Document Type: Schematic Review

Customer Name: Wistron

TI Product No: CC2340R5

JIRA Ticket: SLWIFHWAPPS-762

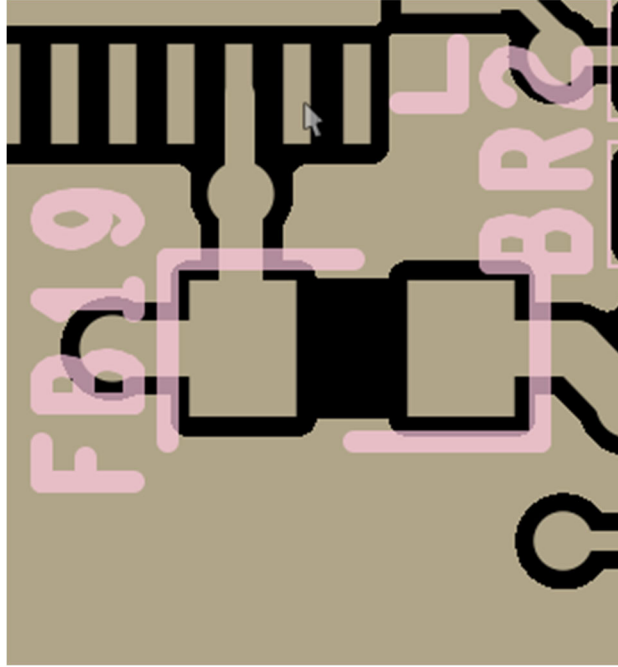
- Pin 18 (DIO22) doesn't support UART TX
- Pin 20 (DIO24) doesn't support UART function
- Pin 25 (RESET) Typically use a pull-up rather than a pull-down since reset is active low
